PIC18FXX2 Rev. C0 Silicon/Data Sheet Errata

The PIC18FXX2 Rev. C0 parts you have received conform functionally to the Device Data Sheet (DS39564B), except for the anomalies described below.

Clarifications/Corrections to the Data Sheet:

In the Device Data Sheet (DS39564B), the following clarifications and corrections should be noted.

FIGURE 1: PINOUT DIAGRAM FOR PIC18F442/452, 44-PIN QFN PACKAGE

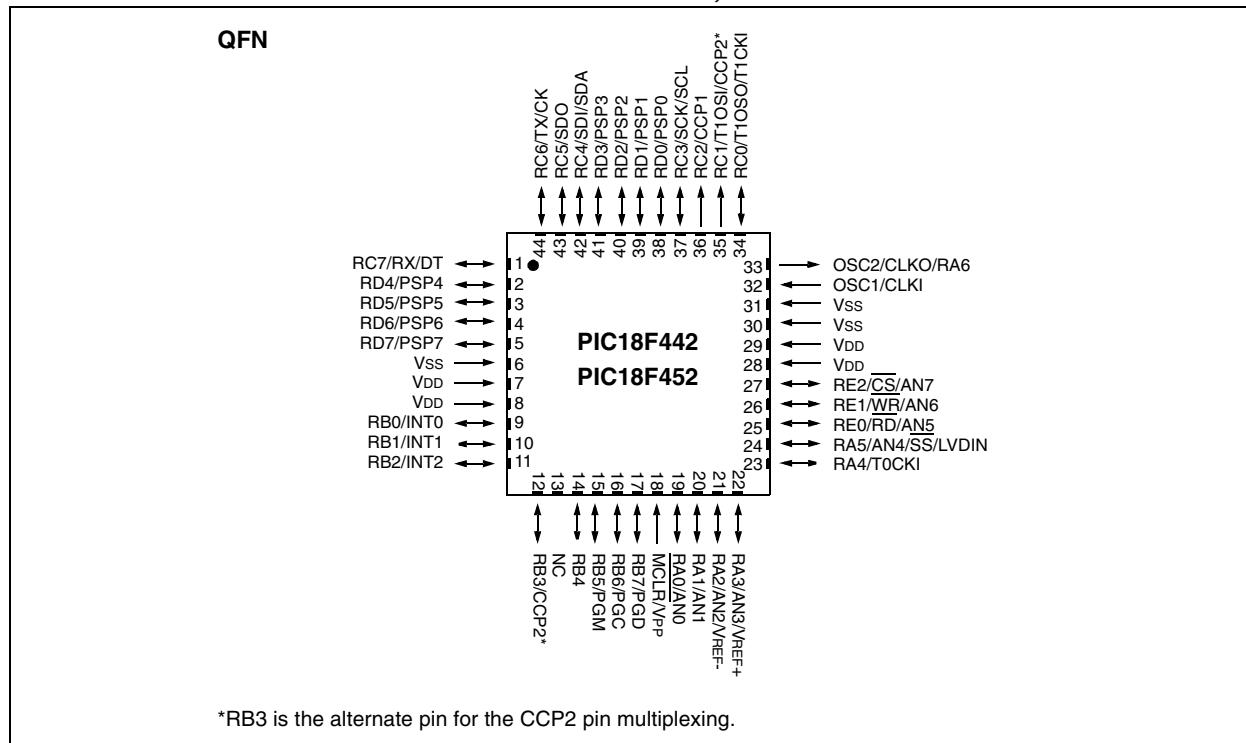
PIC18F442 and PICF452 devices are now offered in 44-pin, near chip scale micro lead frame packages (commonly known as "QFN"). This packaging type has been added to the product line since the latest revision of the Device Data Sheet.

The addition of this option requires the following additions to the Device Data Sheet (DS39564B). The referenced figures and tables follow this text.

1. The "Pin Diagrams" on pages 2-3 of the Data Sheet are amended with the addition of the 44-pin QFN pinout, shown in Figure 1.
2. Table 1-3 of **Section 1.0 "Device Overview"** is replaced with an updated version which adds a column for QFN pin assignments. A row is also added for previously unlisted NC pins. All new information is indicated in **bold**.

FIGURE 3: 44-PIN QFN PACKAGE

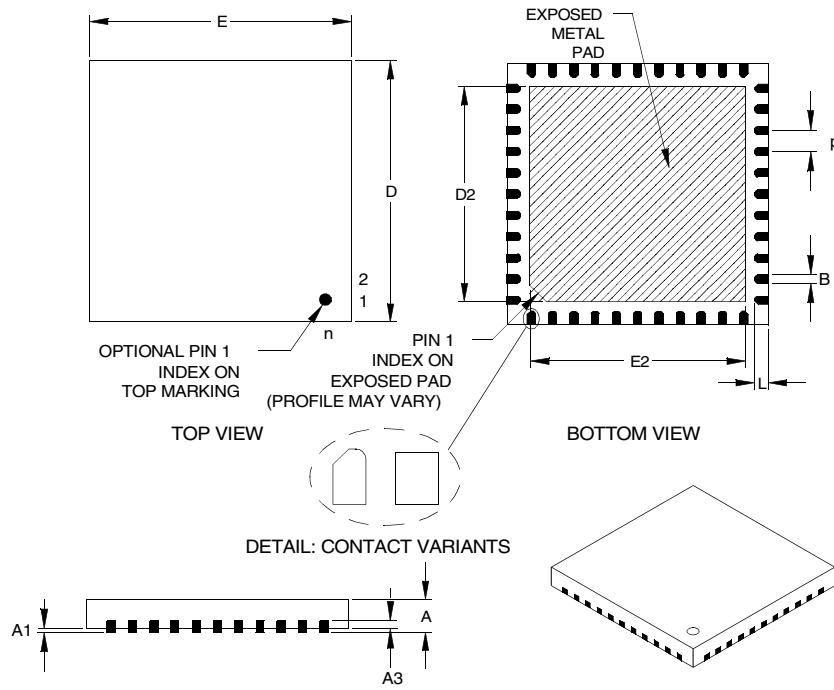
4. **Section 24.2 "Package Details"** is amended to include the mechanical drawing of the 44-pin QFN package, shown in Figure 3.
5. In the "**PIC18FXX2 Product Identification System**" (page 329), the "Package" options are amended to include the new line item:
ML = QFN
6. For the sake of completeness, it is also noted that the package designation "MLF" is now replaced by "QFN" in all occurrences throughout the Device Data Sheet. "MLF" should be considered an obsoleted term.
